KANSAS GEOLOGICAL SURVEY

March 9, 2005

**Re: Construction and Demolition Landfill Permit Compliance
Grant County C&D Landfill, Ulysses, Kansas**

I received your request for comment by the Kansas Geological Survey (KGS) on the proposed Construction & Demolition (C&D) Landfill for Grant County. The proposed disposal area is located in the W $\frac{1}{2}$ SE $\frac{1}{4}$ of Section 25, Tier 28S, Range 37W.

FIGURE 1

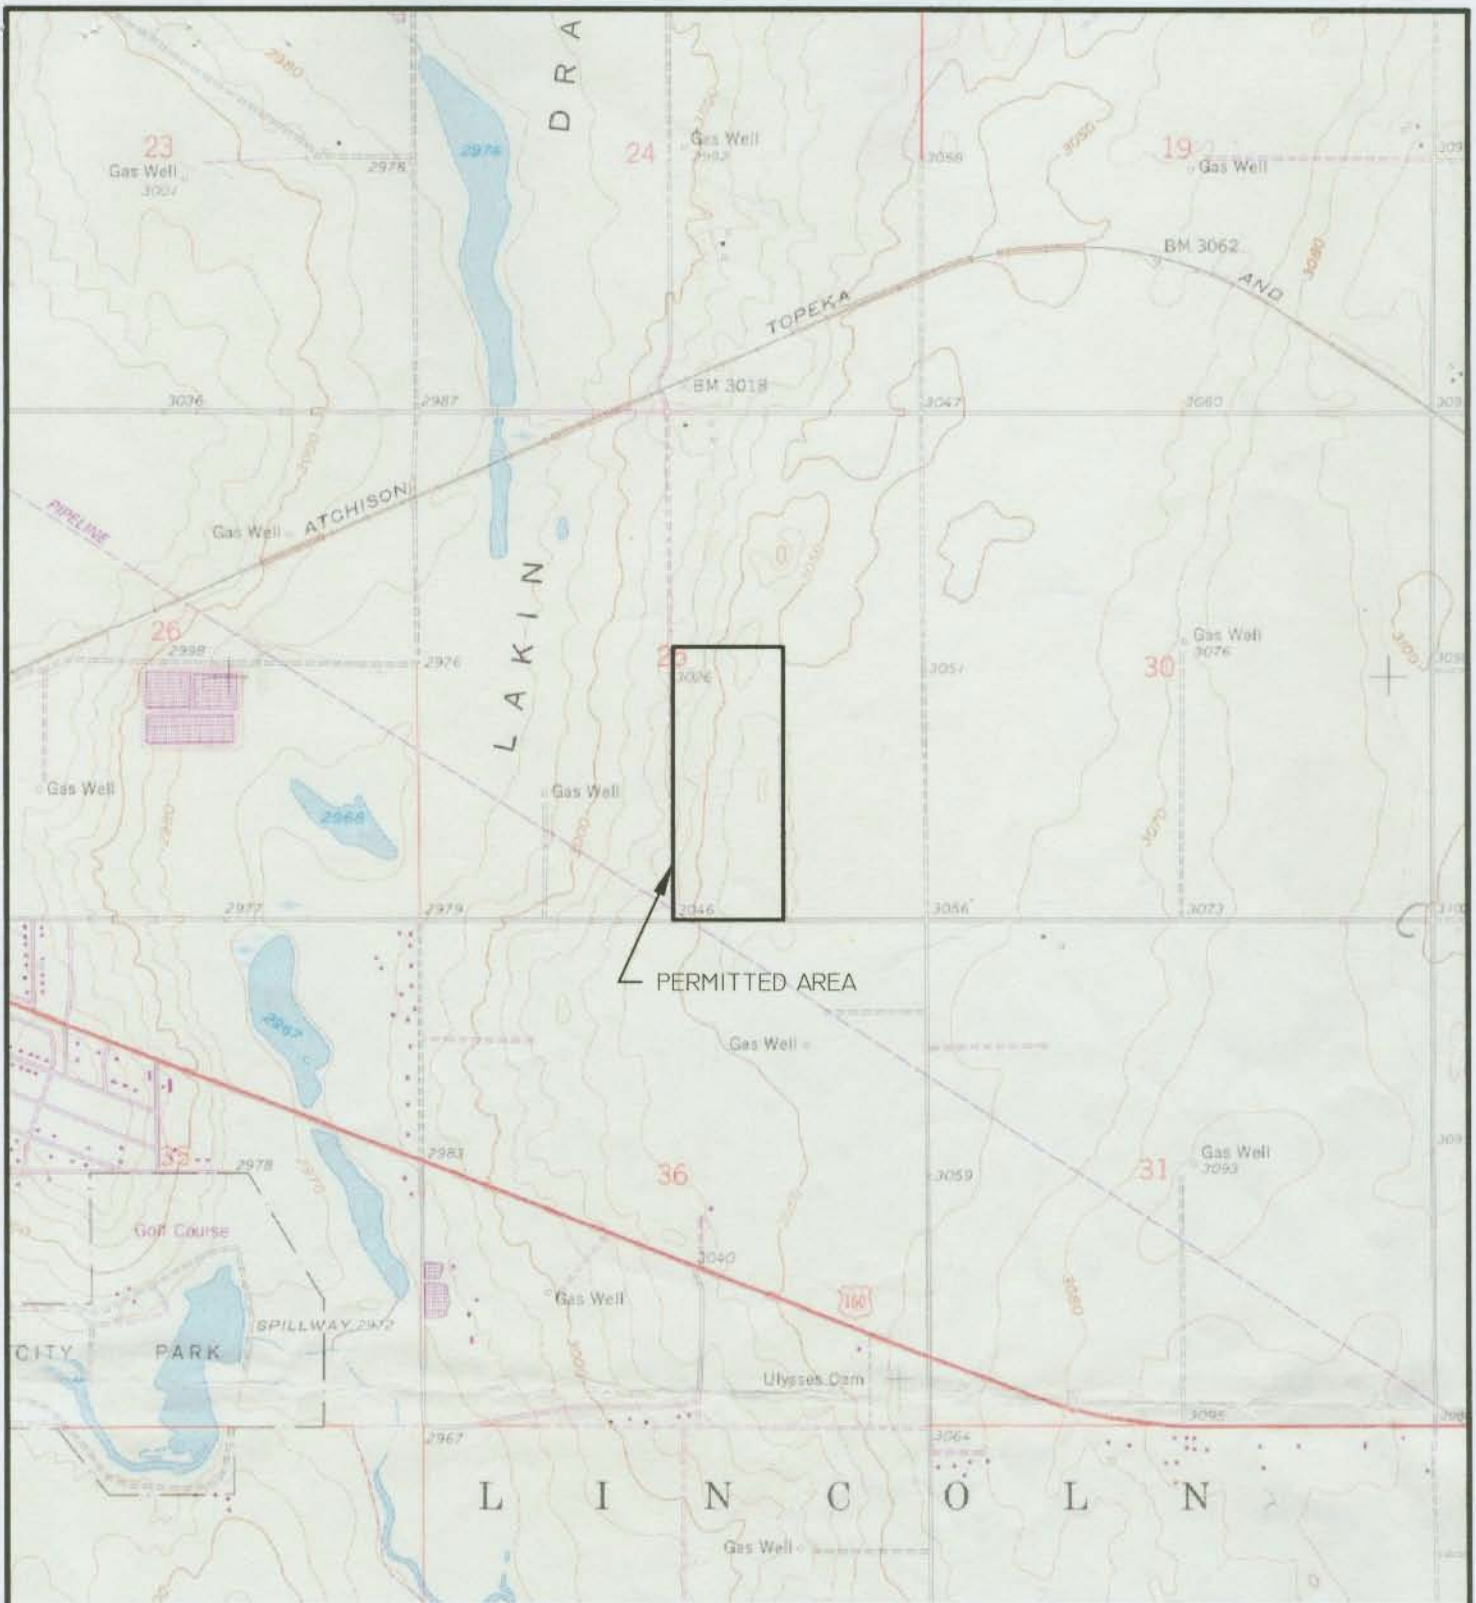
Your letter of notification included a portion of the Ulysses 7.5' topographic quadrangle, a site plan, a geologic stability assessment, and two earthquake hazard maps. The geologic stability assessment is primarily a review of existing geologic literature. The report refers to some well logs for monitor wells installed at the site and provides a two sentence summary of the well log data. No material property data was provided.

Landslides: The land surface has a gentle slope gradient; however the local relief across the site, as determined from the topographic quadrangle, is greater than the 20 feet stated in your geological assessment states. The slope gradient for the site is not reported, but a range of values could be easily calculated. No information about the landslide susceptibility of the subsurface materials at the site. KGS Bulletin 168 reports that this material is Pleistocene alluvium, loess, and paleosols. In general alluvium and loess are relatively stable and paleosols have variable stability. Since the C & D waste will be placed in trenches and no surcharge will be placed on the soils, the probability of landslides at this site is low. Stability of trench walls is always a concern, and proper precautions should be taken.

Poor Foundation conditions: I agree that the probability of liquefaction is low. I have one concern that needs to be addressed. The Ulysses 7.5' topographic quadrangle has several depressions. Two of these depressions are within a mile of the landfill site.

Summary: The KGS recommends that the geologic stability assessment be revised to address the above comments prior to being submitted with the final application. The KGS has only reviewed this assessment with respect to "unstable areas" defined as landslides, karst, and poor foundation conditions. Unanticipated stability problems that will need to be addressed may be encountered during detailed site characterization or landfill operation.
